APRIL - JUNE 1989 ISSUE 25

SECTION 3 - AMIGA

25/3-1.1 A2000 PCB FIELD UPGRADE TO REVISION LEVEL 4.5. (CONT)

DIAGRAM 25/3-3.2

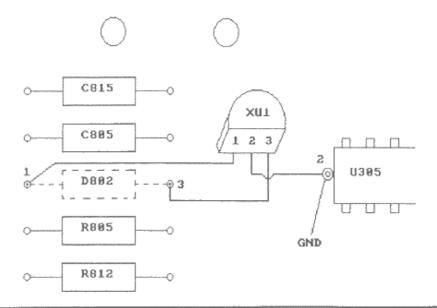
25/3-3.1 A2000 GURU MESSAGE ON POWER UP W/ REV 6 PCB.

NEW DRAMS MAY RETAIN DATA FOR AS LONG AS FIVE (5) MINUTES AFTER POWER OFF. AN ADVISORY MESSAGE ON POWER UP MAY INDICATE THAT THE ERROR MESSAGE GENERATED BY POWER OFF HAS BEEN RETAINED. PRESSING THE LEFT MOUSE BUTTON WILL ALLOW THE SYSTEM TO RESUME A NORMAL START UP.

A MITSUMI PST518B, RESET IC (CBM PN# 328156-02) SHOULD BE INSTALLED AS FOLLOWS:

LOCATE U305 (TO THE LEFT OF CN303, 34 PIN DRIVE CABLE). LOCATE D802 (DOWN, TO THE RIGHT OF U305). INSTALL PST518B (DESIGNATED XU1) USING INSULATION TUBING AS REQUIRED TO PREVENT THE POSSIBLITY OF SHORTS.

SOLDER PIN 1 OF XU1 TO +5 VOLT SIDE OF DIODE D802. SOLDER PIN 2 OF XU1 TO GND, USE PLATED HOLE AT THE BASE OF IC U305. SOLDER PIN 3 OF XU1 TO THE ANODE SIDE OF DIODE D802.
